Title: Advisory Committee on Reactor Safeguards
Thermal Hydraulic Phenomena Subcommittee

Date: Wednesday, August 22, 2001

UNITED STATES NUCLEAR REGULATORY COMMISSION'S
ADVISORY COMMITTEE ON REACTOR SAFEGUARDS

Steady State In-Channel Axial Void Fraction

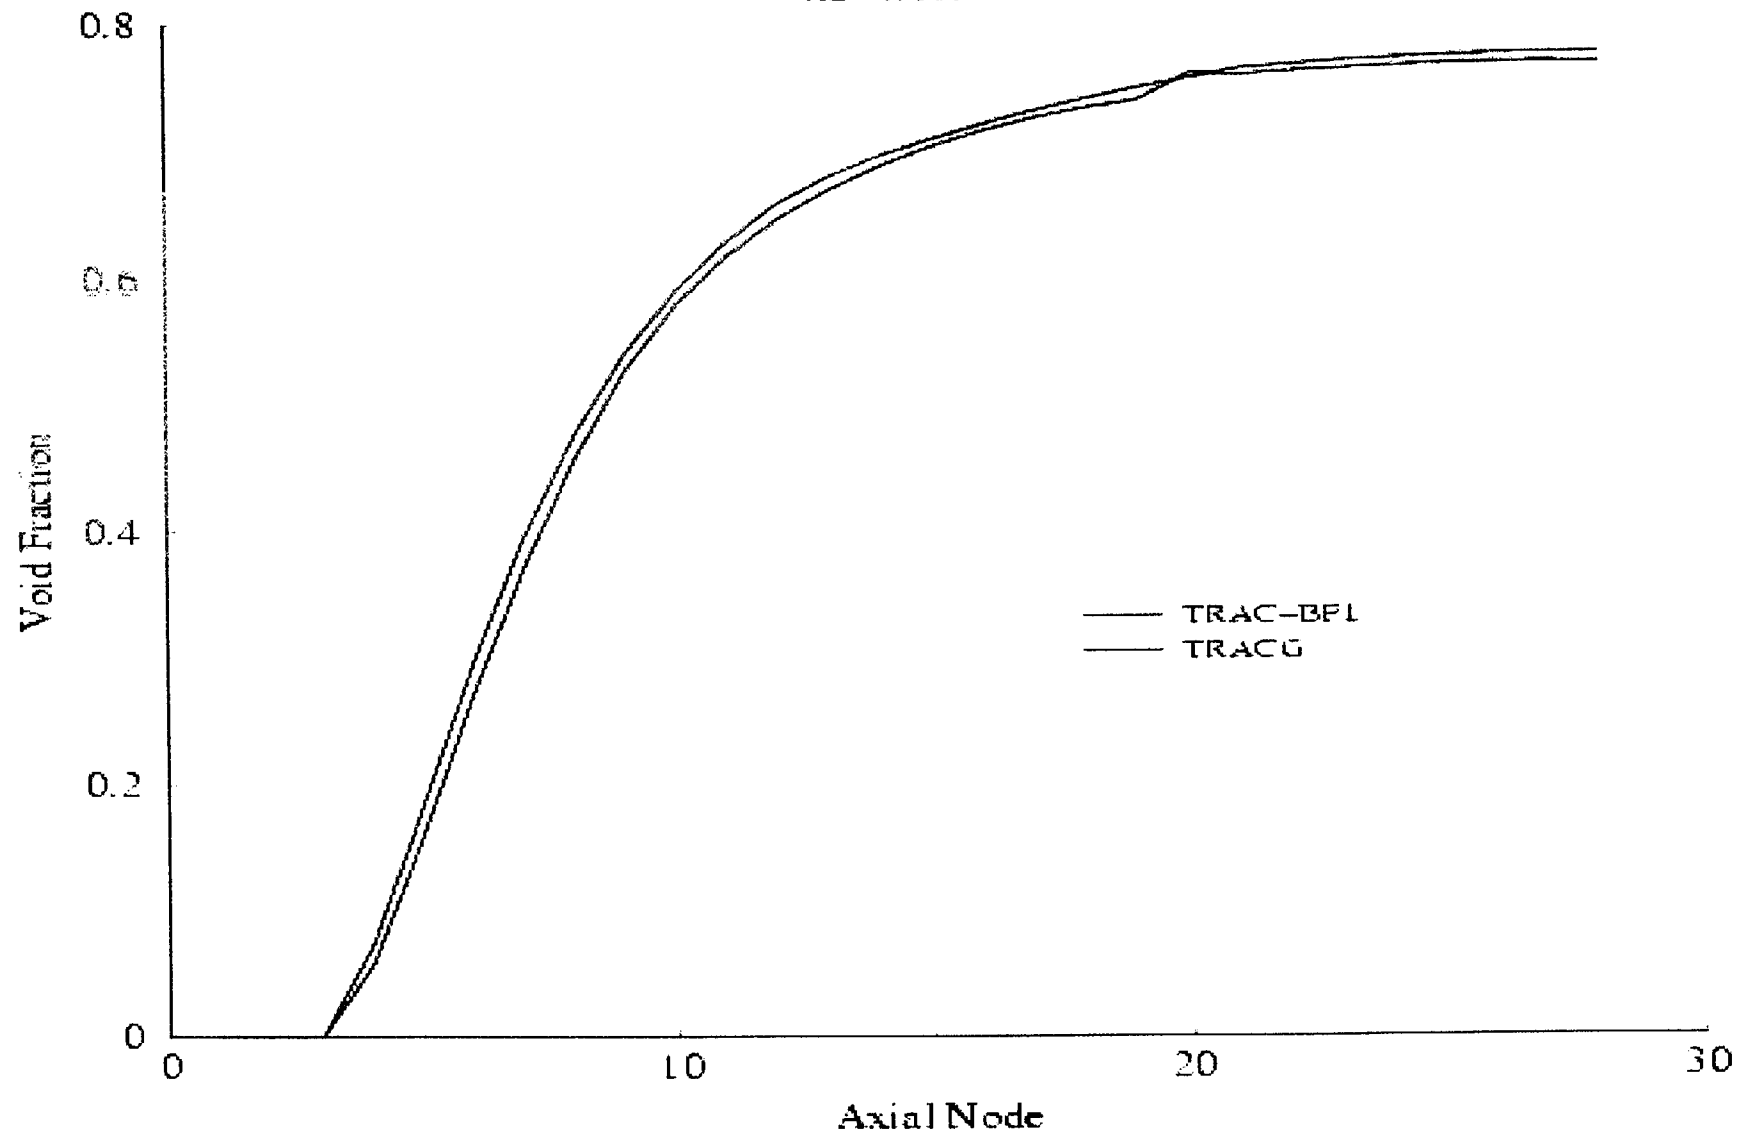
1 I just wanted to put up again the axial
2 void fraction profile radially collapsed, one-
3 dimensional. The only difference is this little
4 change here and that comes in because of the existence
5 of the part length rods and that's the TRACB modeling.
6 There's a difference. You could go into the part
7 length rod and region. But again, as you'll see, it
8 does not have an effect on the overall bottom line
9 answer.

1 this and you gave the key answer. This tells me
2 nothing at all how good the model is.

Figure 5 Total Reactor Power for Simulated Pressurization Transient

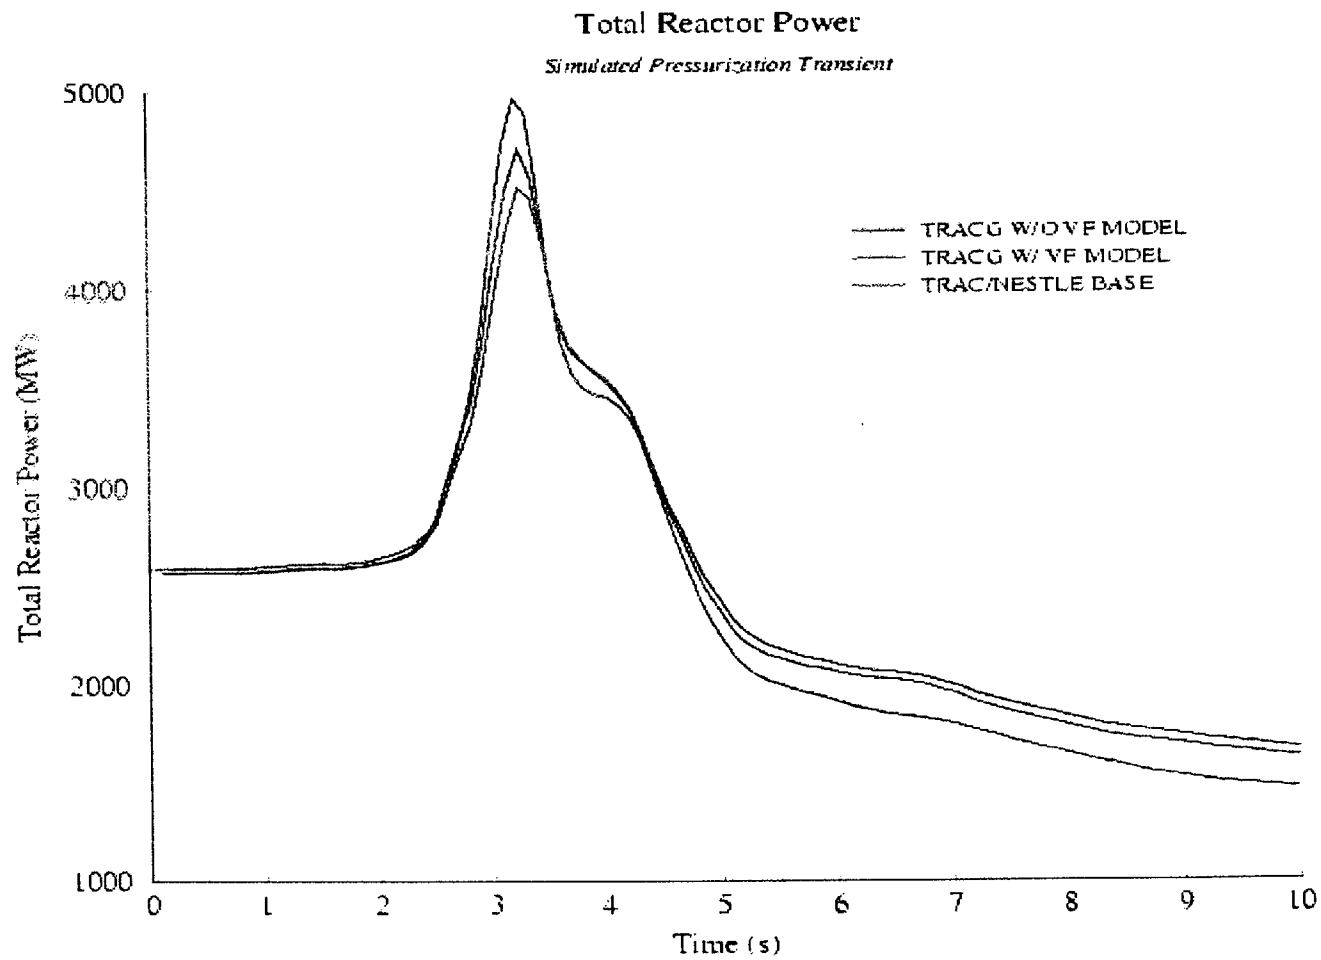
- Simulated MSIV closure without SCRAM using complete deck to generate boundary conditions
- Modeled transient with different modeling options

Figure 6 Comparison of Different Monte Carlo Evaluations of the Same GNF Lattice

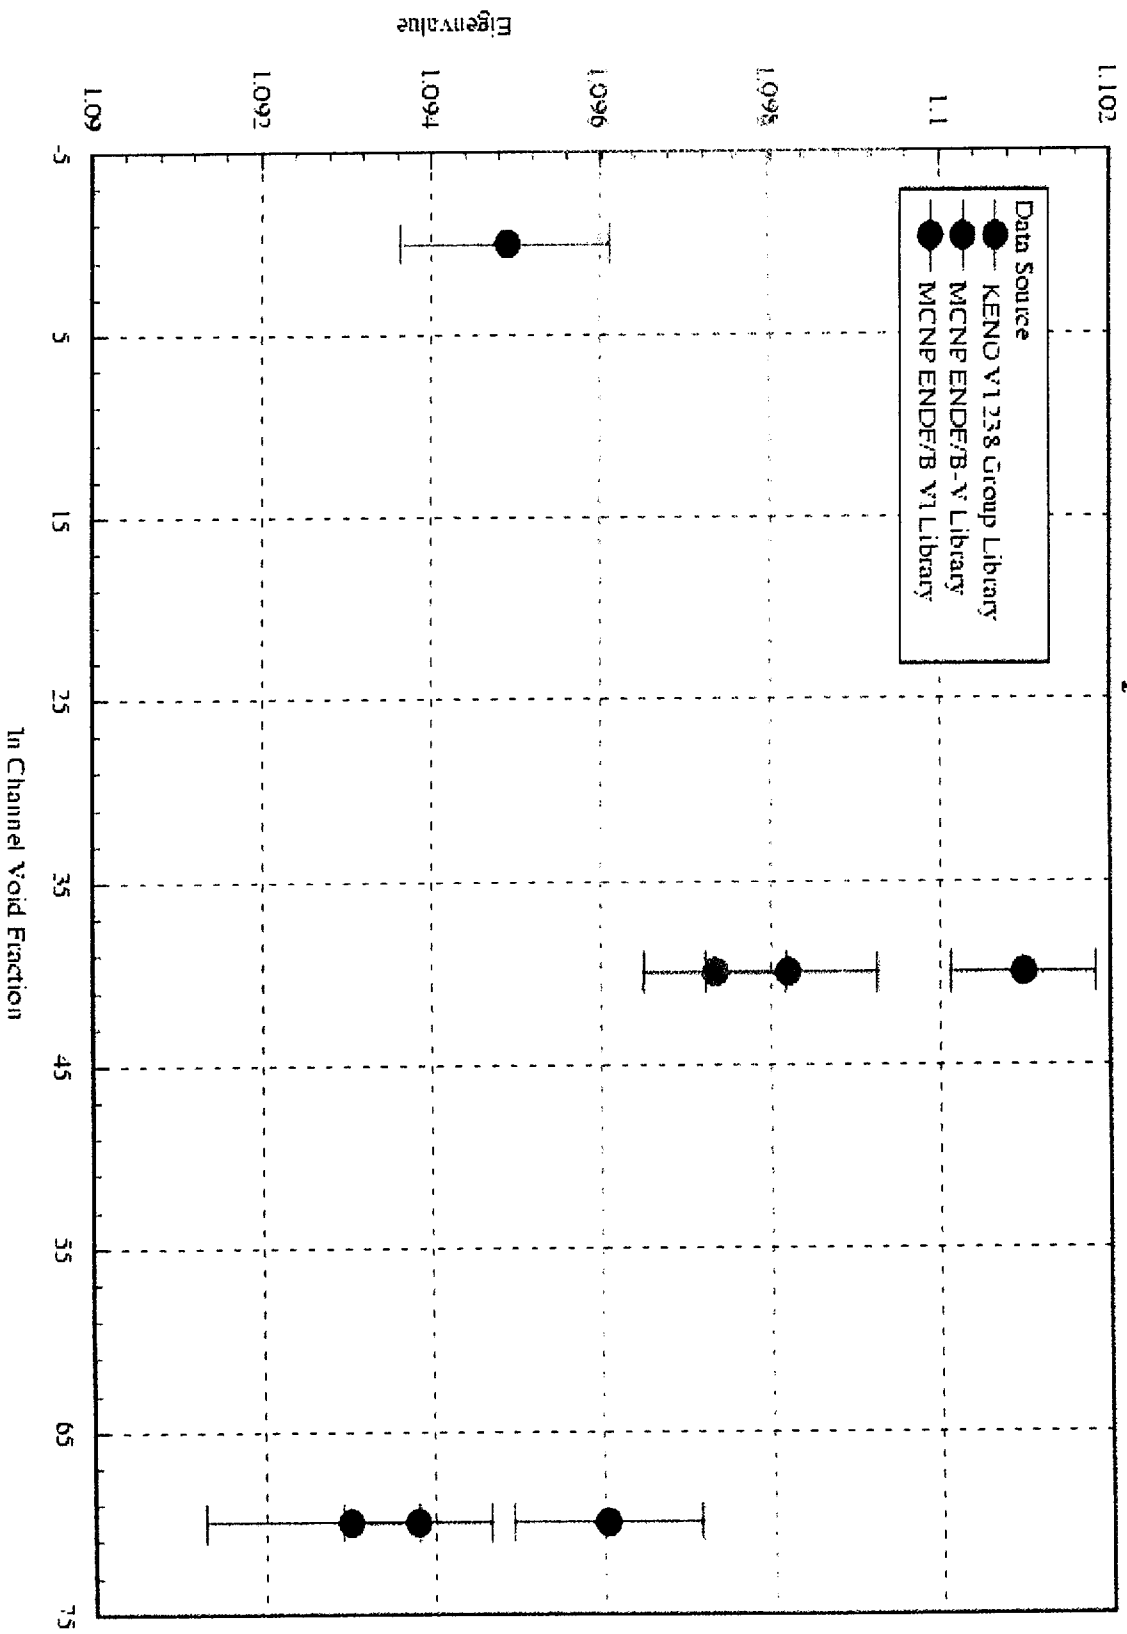
7 But if you look at this plot, it would be
8 equally valid to take the prediction down here versus
9 the prediction up here because again, this is a value
10 which is not a point value. All these values here
11 have been deemed to be effectively the same number
12 within the way that MCMP is usually applied. And if
13 you take this difference and you span this across this
14 curve, it will have an effect on the predicted power
15 response.

16 It's not going to be significant, but
17 there'll be an effect, and that's not accounted for in
18 this model and that's basically the problem that I had
19 with it, and that's why the SER is written as it is on
20 this particular model. It doesn't have a significant
21 effect on the bottom line answer, which is energy
22 deposition, but I don't believe that it's well enough
23 quantified in this context simply because of the lack
24 of the consideration of this uncertainty band.

- MCNP, like all Monte Carlo codes, does not provide user with single valued results
- Predicted eigenvalues are statistically derived and have uncertainty
- Uncertainty represented by the 95th percentile confidence interval needs to be accounted for
- Staff predicted uncertainty bands would lead to small differences in TRACG predictions if applied to results
- Effect of model is minimal - not well justified
